Date: December 20, 2019
To: Plan Holders
Subject: Addendum No. 1 to the Bidding Documents for: ITB No. 2020-001

METCAD Mechanical System Replacement Project
1905 East Main Street
Urbana, Illinois 61802

Addendum No. 1 becomes a part of the bidding and contract documents and modifies the original bidding documents, dated December 4, 2019. Acknowledge receipt of Addendum No. 1 in the space provided on Bid Form. **FAILURE TO DO SO MAY SUBJECT BIDDER TO DISQUALIFICATION.**

AD-1

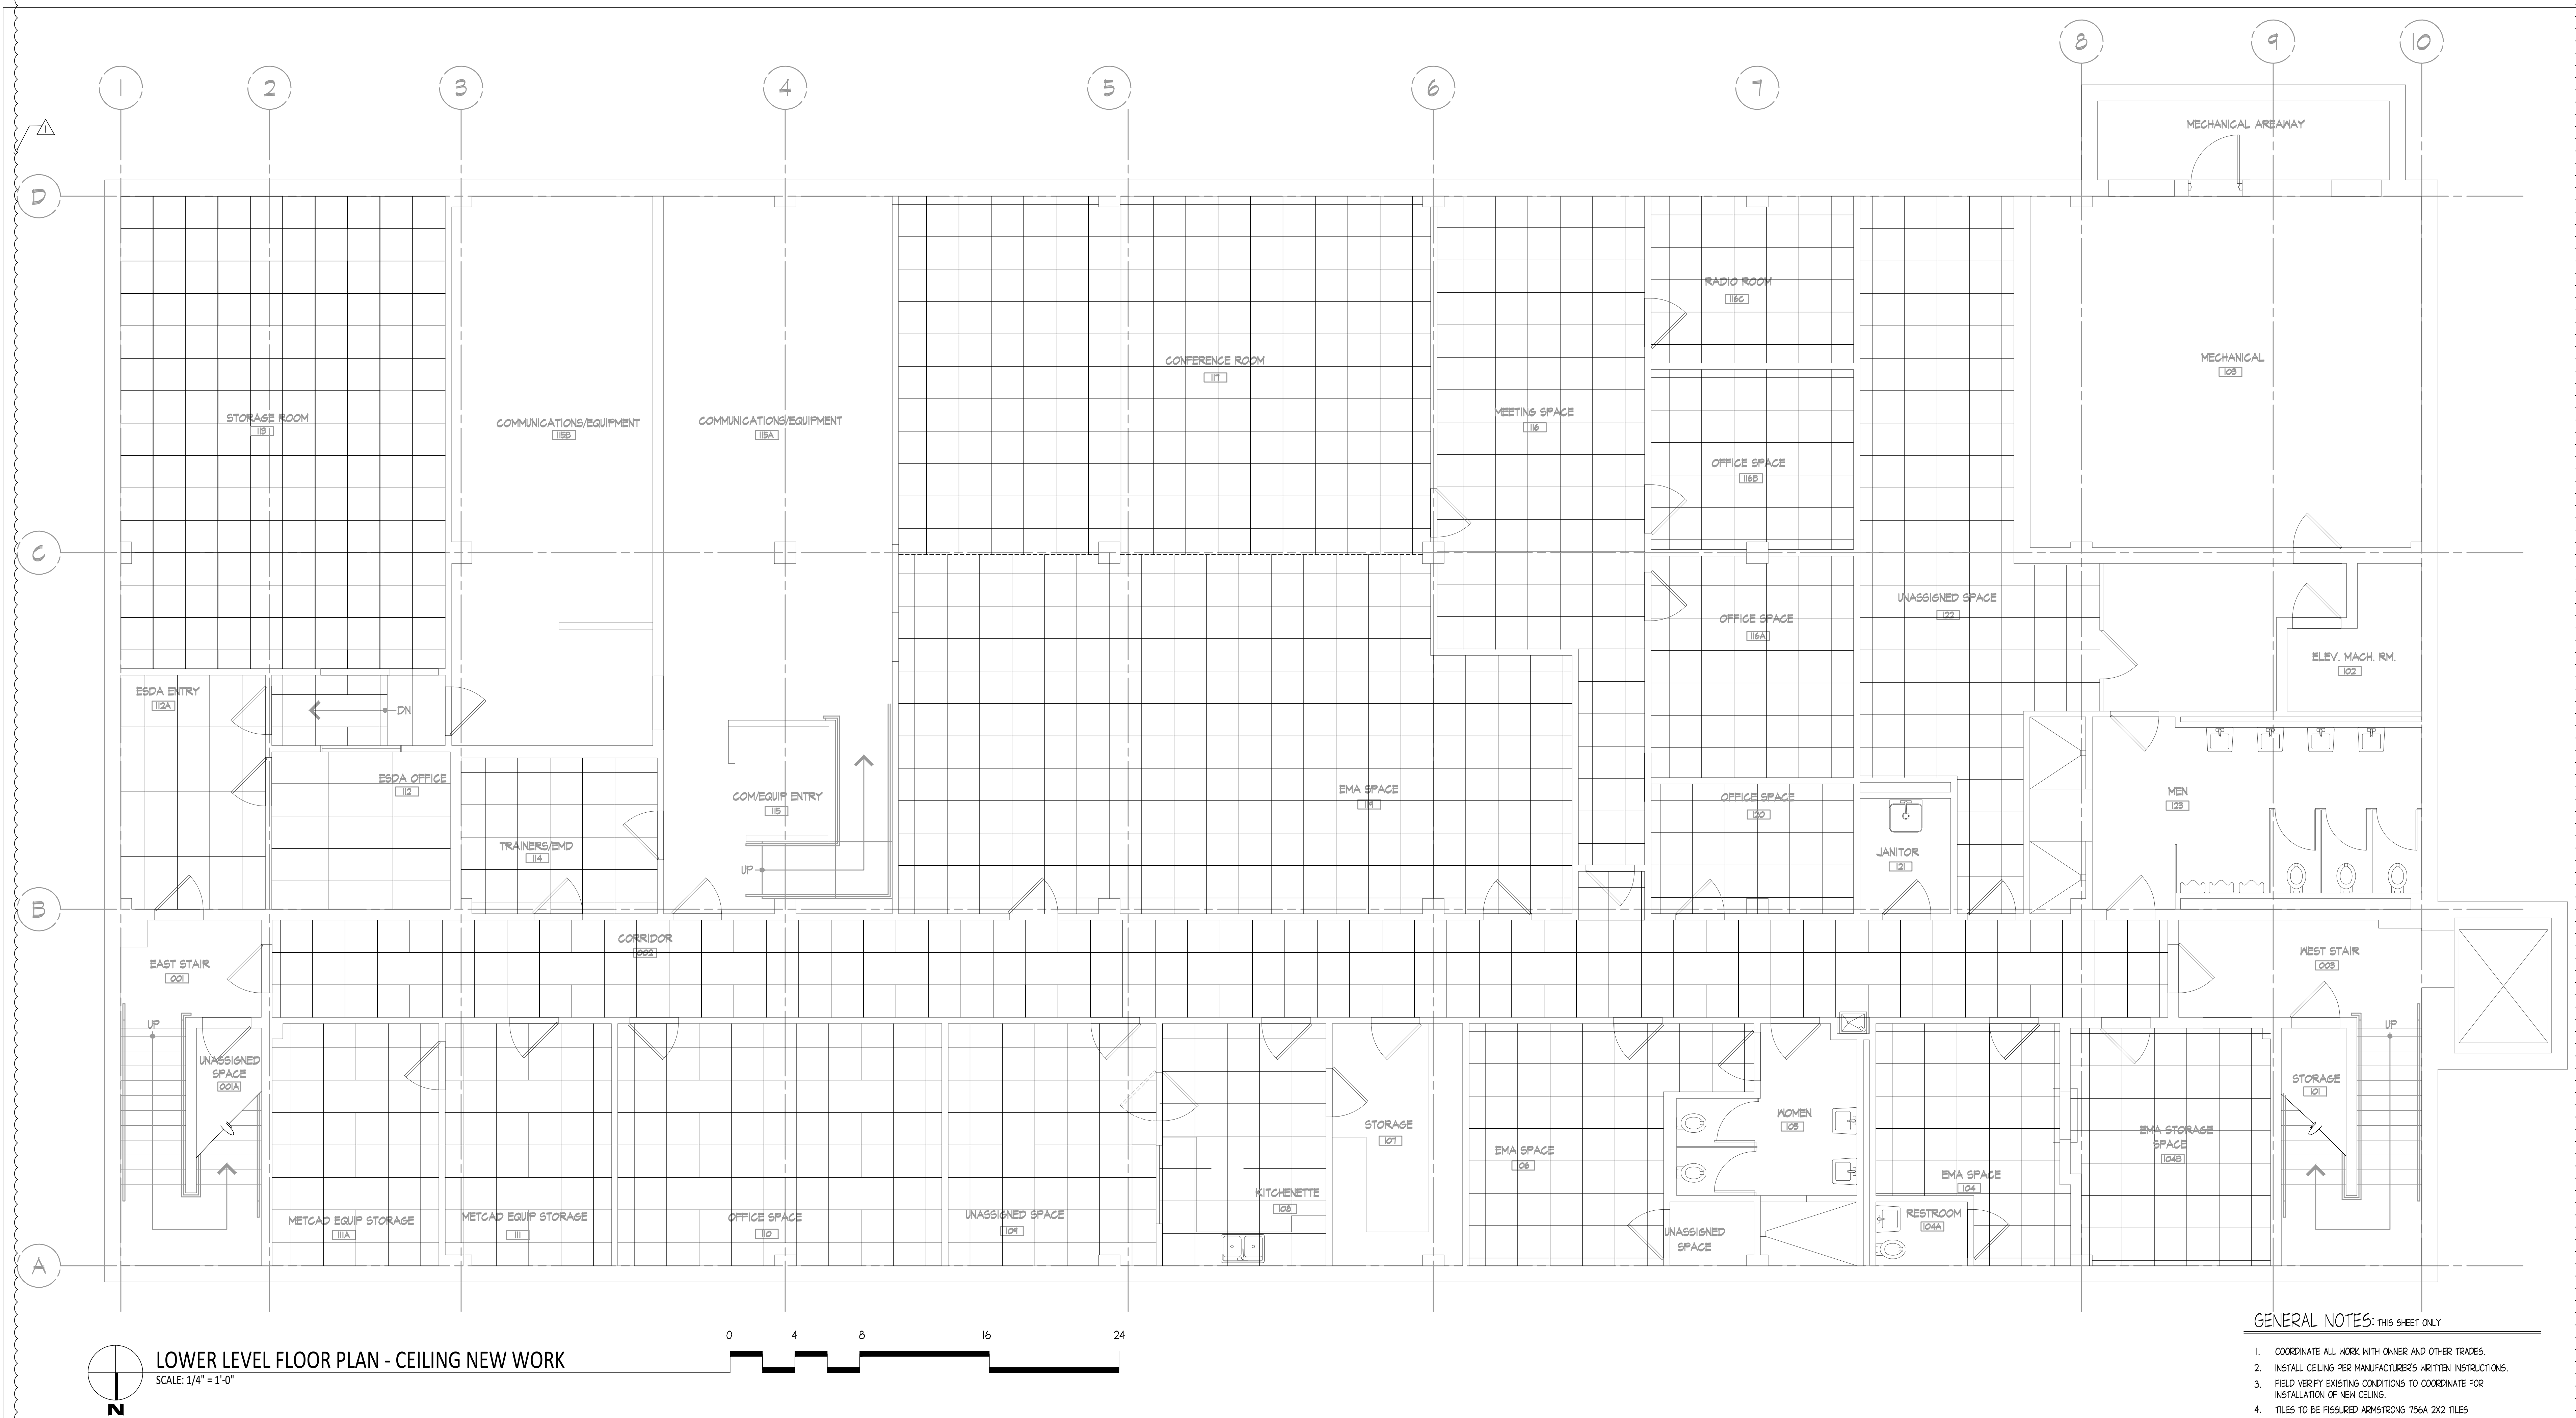
- b. Add "AD-1 LOWER LEVEL FLOOR PLAN - ARCHITECTURAL DEMOLITION" and "A-1 LOWER LEVEL FLOOR PLAN - ARCHITECTURAL" to sheet list.
2. Sheet AD-1 - Lower Level Floor Plan - Architectural Demolition

- a. See attached new Sheet AD-1.
3. Sheet A-1 - Lower Level Floor Plan - Architectural
 - a. See attached new Sheet A-1.
4. Sheet HD-1 - Lower Level Floor Plan - Heating Demolition

SHEET: H-2

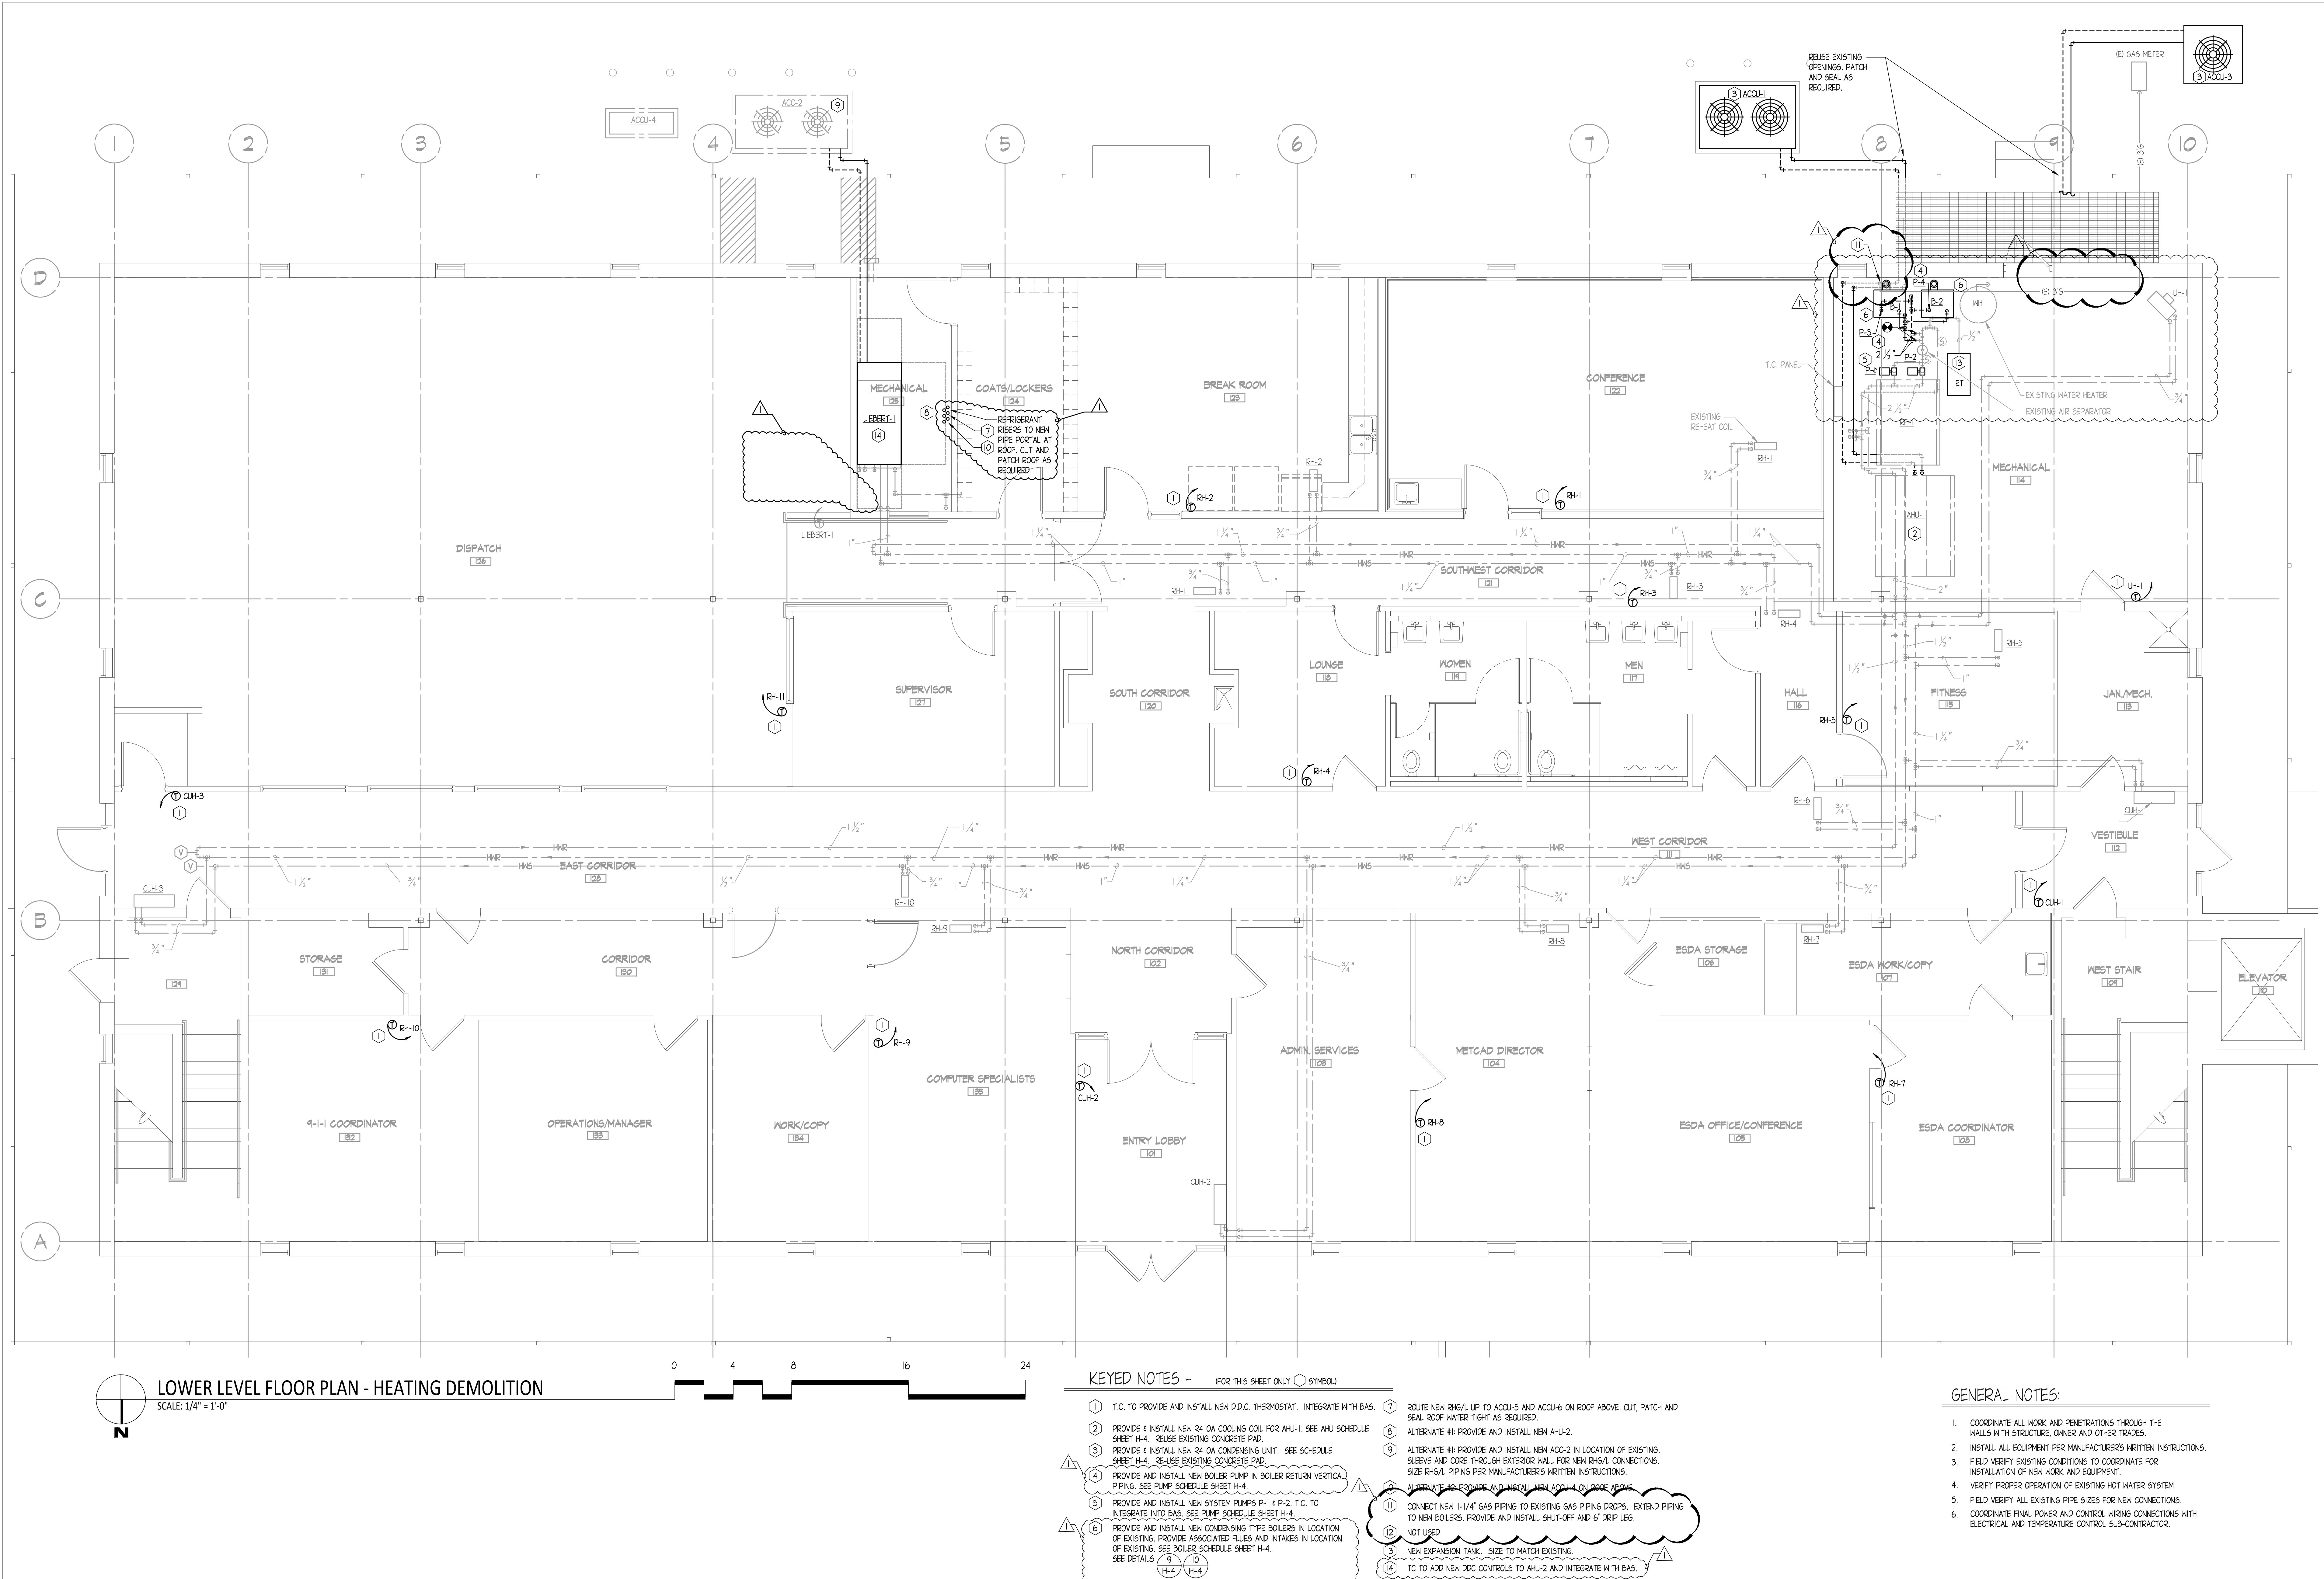
7. Sheet H-2 - First Floor Plan - Heating New Work - See Attached Revised Sheet H-2
 - a. Mechanical 114 - Delete new gas piping as shown on attached drawing, H-2.

- b. Existing gas piping shown to remain as shown on attached drawing, H-2.
 - c. Delete Note 11. Replace Note 11 with the following: "Connect new 1-1/4" gas piping to existing gas piping drops. Existing piping to new boilers. Provide and install shut-off and 6" drip leg."

- d. Delete note 12. Replace note 12 with the following: "Not used."
 - e. Modified location of refrigerant risers from level 00 to level 01 within Room 125 MECHANICAL.

- f. Added Keyed Note: "TC to add new DDC controls to AHU-2 and integrate with BAS."
 - g. Revised location of new boilers B-1 and B-2 as shown.
- 8. Sheet H-3 - Roof Plan - See Attached Revised Sheet H-3

SHEET: H-3

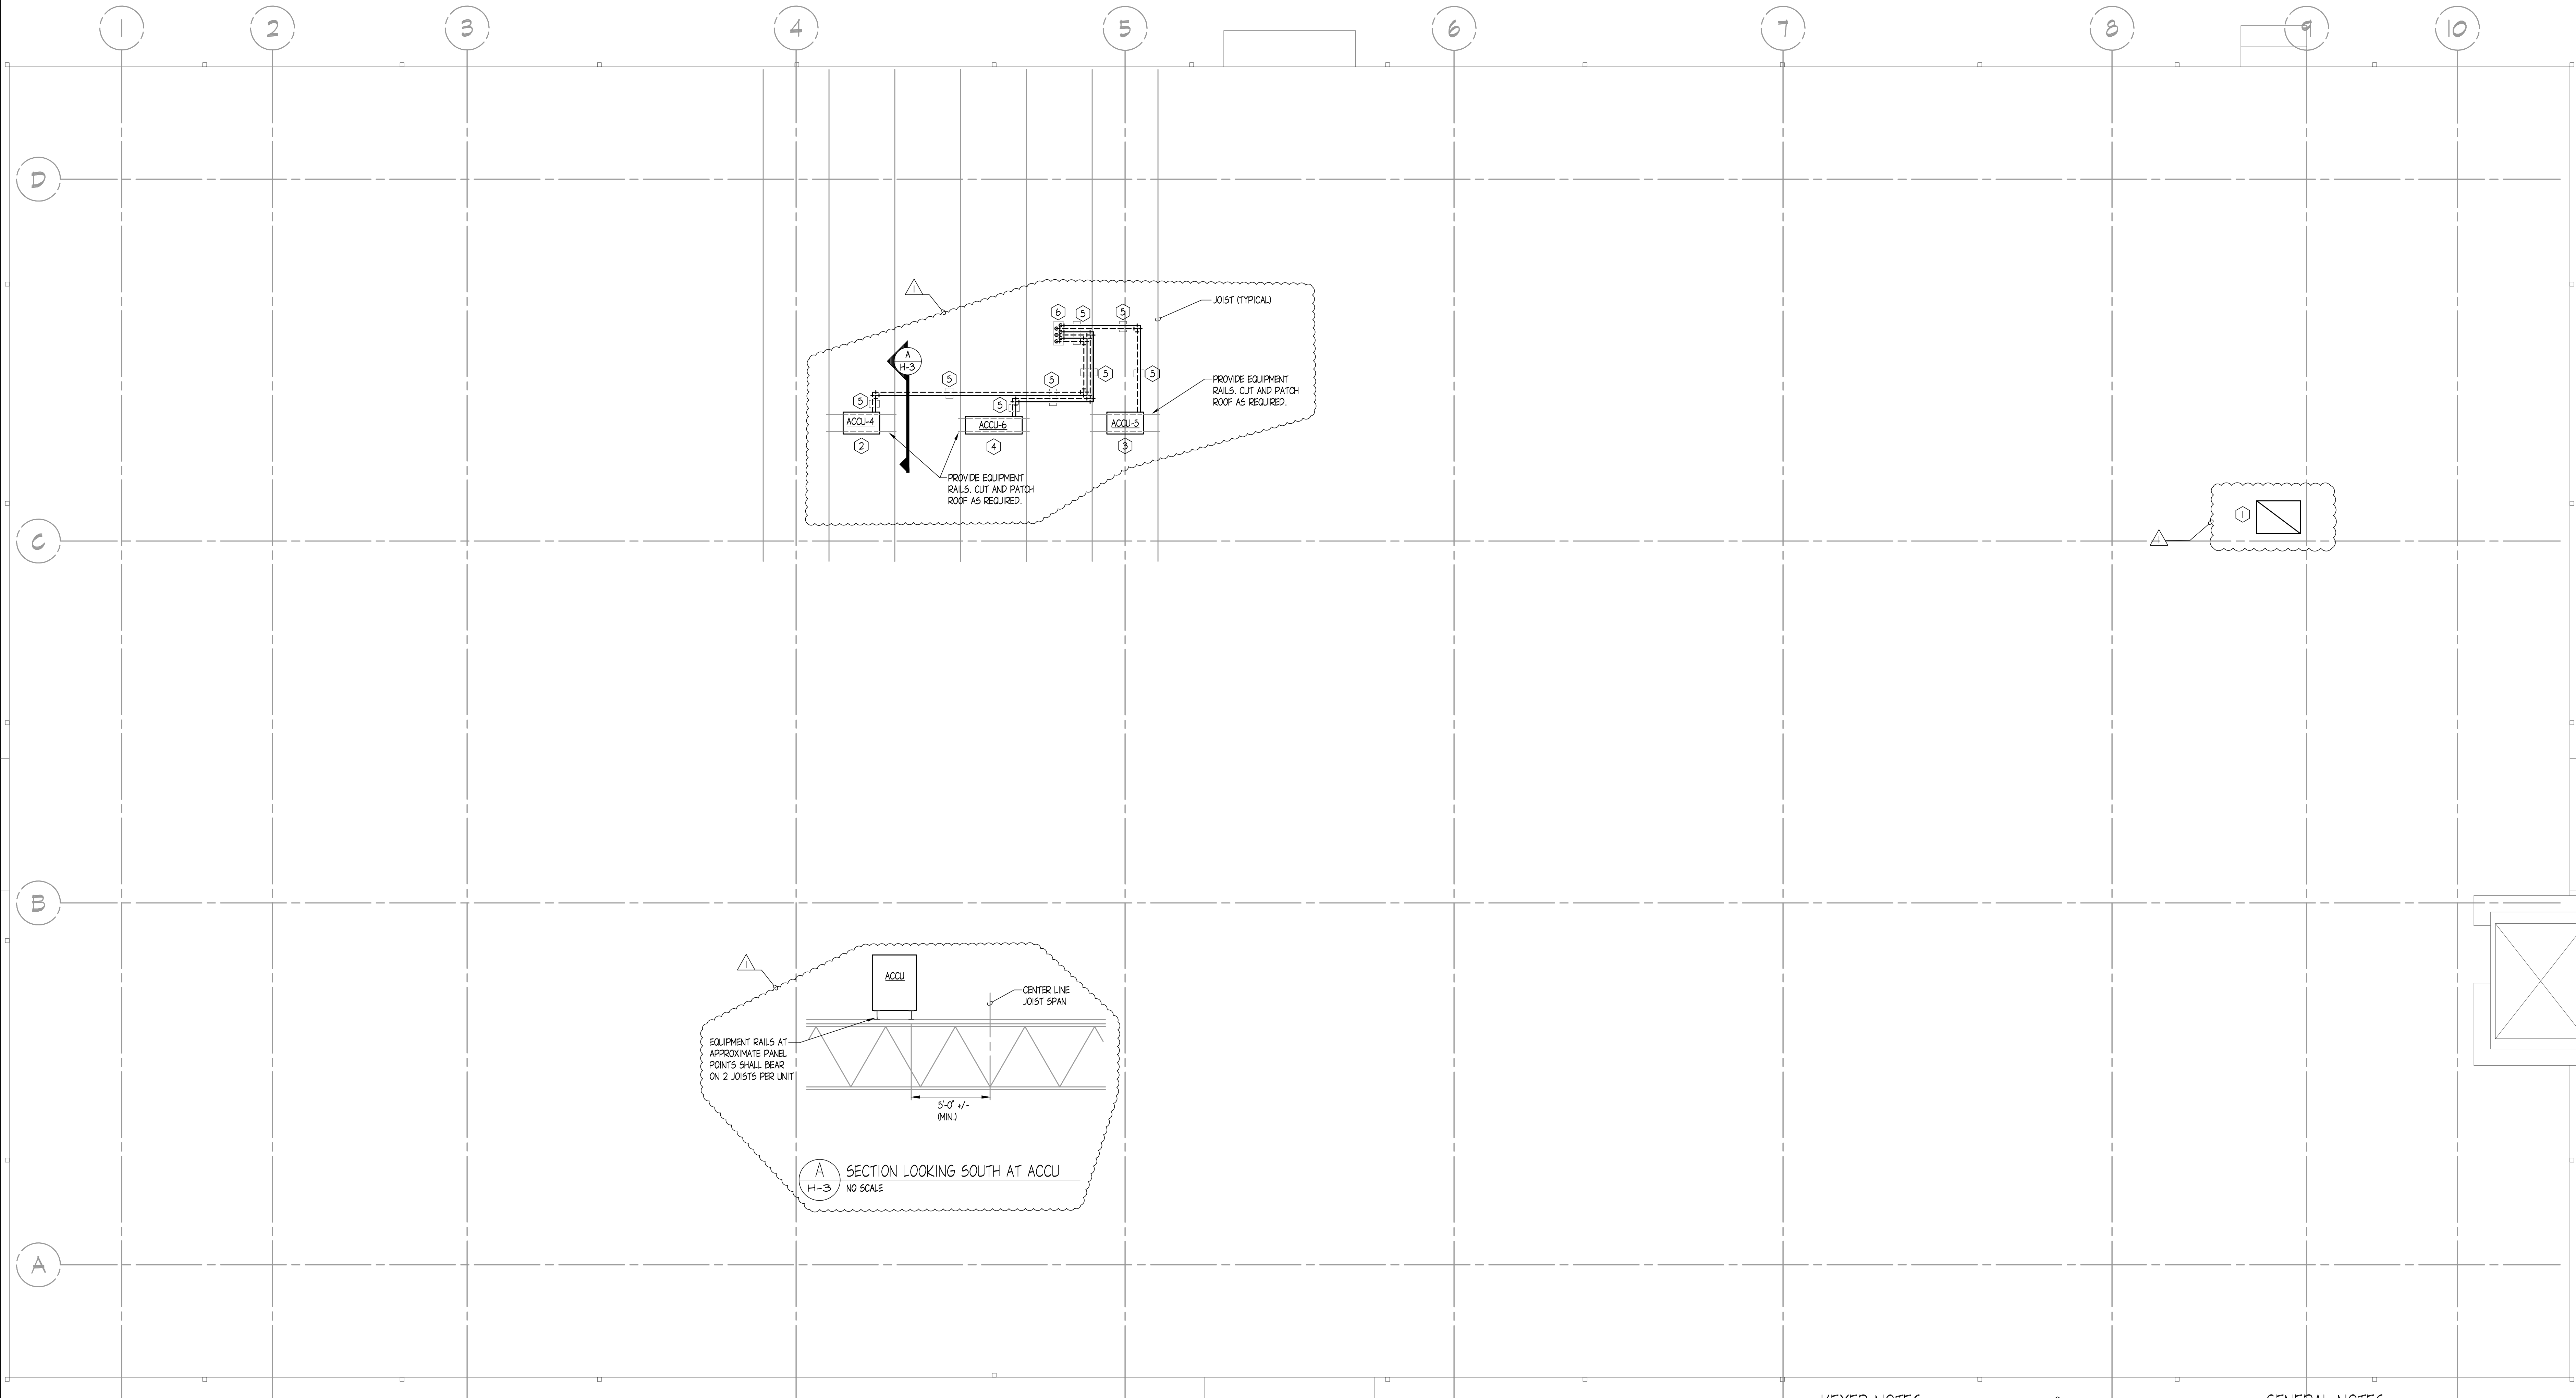
- a. Revised location of roof mounted condensing units and added structural detail.
- 9. Sheet H-4 - Heating Abbreviations, Details and Schedules - See Attached Revised Sheet H-4
